SUNNICA ENERGY FARM

8.72 Applicant's Response to Local Planning Authorities Deadline 4
Submissions

**Sunnica Energy Farm
Development Consent Order 202[x]**

**8.72 Applicant's Response to Local Planning Authorities Deadline 4
Submissions**

Screenshot from Terrestrial habitats and flora report (Figure 2.2 Flora surveys 2019 to 2020. Page 3 of 10).

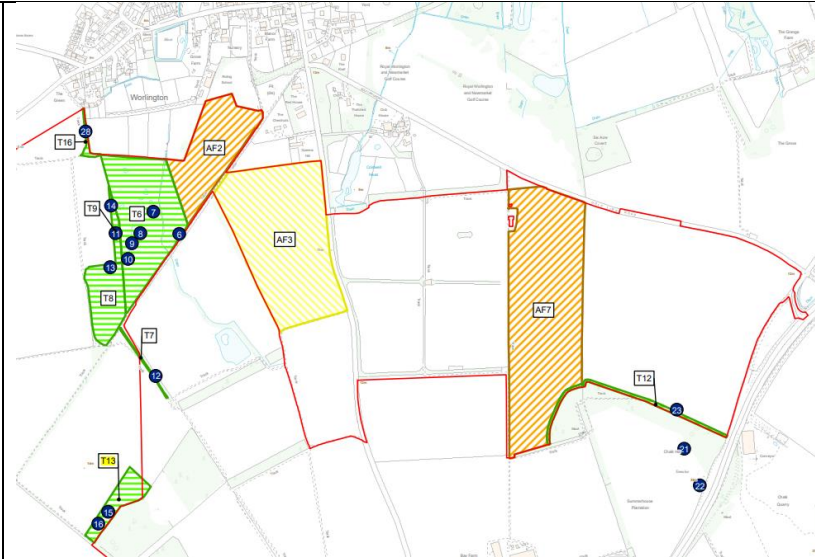
The applicant's response at REP3-091 does not clarify where the grassland will be lost and does not address why the mitigation hierarchy was not engaged. However, the applicant has confirmed informally (workshop of 1.12.22) that the acid grassland will be lost from the east of parcel E13 (T13 assessed to be of county importance (Pg 8C-35 APP-079) and E13 eastern margin assessed to be on county-regional importance for invertebrates (pg 8D-21 APP-080)). The Council's position is that the mitigation hierarchy should be engaged and the acid grassland and associated invertebrate

population avoided not least because of the difficulty in translocating turfs and the constraints to management that would occur as a result of SC using ECO3 as set out in the LIR at 8.49-8.51.

Screenshot from Figure 3-1 Sunnica East Parameter Plan.

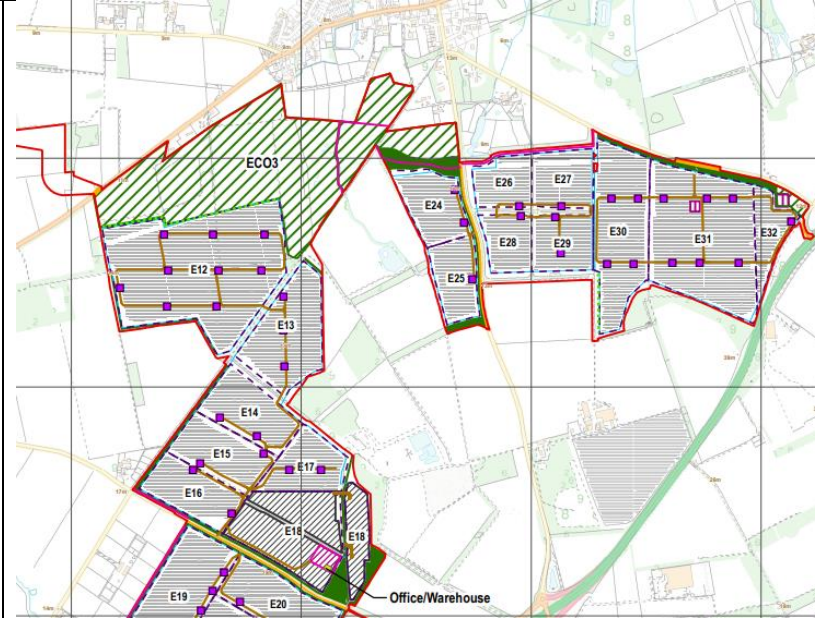
WSC agree with SWT that the BNG Metric 3.1 does not recognise species level impacts and would add that BNG is intended to be additional to existing habitat and species protections.

WSC would also add that the proposals should not contribute to the decline in biodiversity in striving to address the climate crisis.
